# SERVICE BULLETIN

Service Bulletin No.: DAC1-76-02 Rev 0

Title: Mixture Cable Routing

Figure 1 – Looking Aft on Firewall

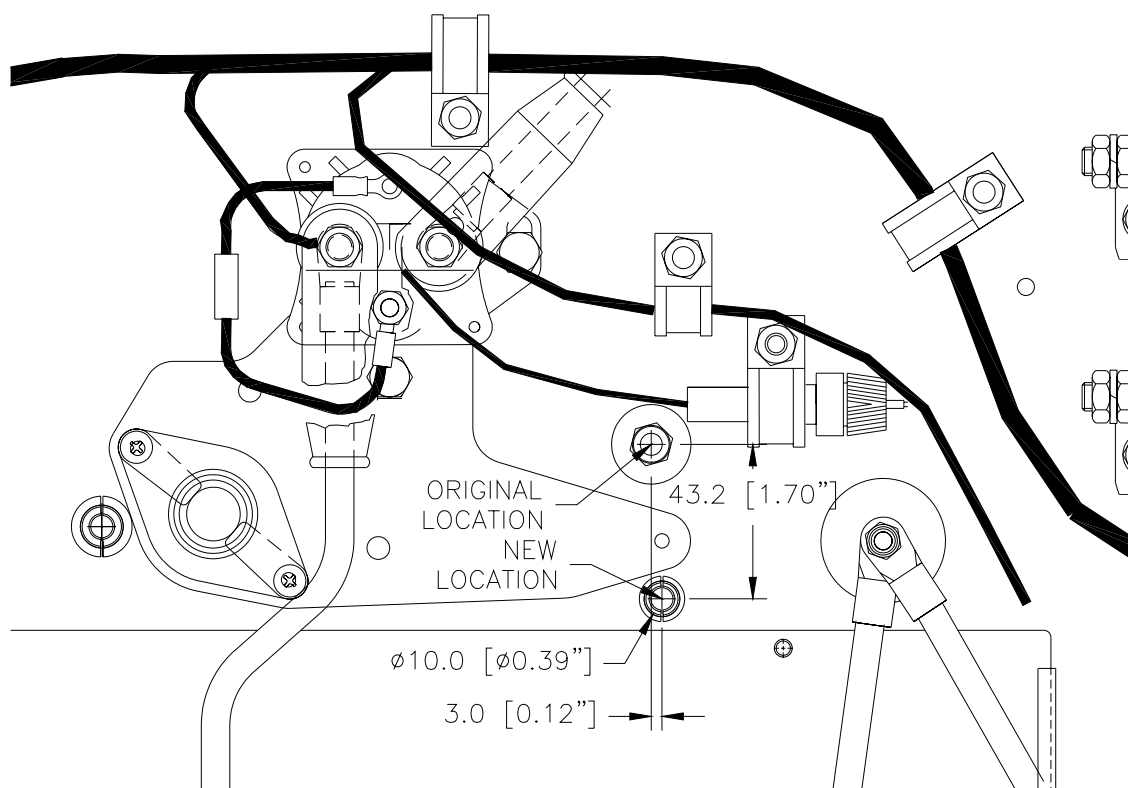
1. **ATA Code:** 7611
2. **Effectivity:** DA20-C1 aircraft.
3. **General:** This service bulletin addresses the relocation of the firewall penetrations for the mixture cable to reduce the possibility of the cable kinking.
4. **Compliance:** Compliance with this service bulletin for aircraft with MOD0085 Reversed Instrument Panel and MOD0137 Garmin GTX330 is highly recommended. Compliance for other aircraft is at the owner's discretion.
5. **Approval:** Engineering data referenced or contained in this service bulletin is approved as part of the type design.
6. **Labour:** Approximately 3 hours will be required to accomplish this service bulletin.

- 10.1 Remove the mixture cable by performing steps 1-17 in section 3 A, "Remove the Mixture Control Bowden Cable", chapter 76-00 of the Maintenance Manual.
- 10.2 Mark the location of the new firewall hole as shown in Fig. 1. Drill a pilot hole from the front side. Open the hole to the final diameter 10mm (0.40") using a step drill. Use care not to damage the surrounding firewall or equipment.
- 10.3 Plug the original hole in the firewall by installing an AN3 bolt from the front, with two AN970-3 washers and one MS21044N3 nut. Ensure the AN3 bolt has sufficient thread engagement. Use firewall sealant (MIL-S-38249 Type 1).
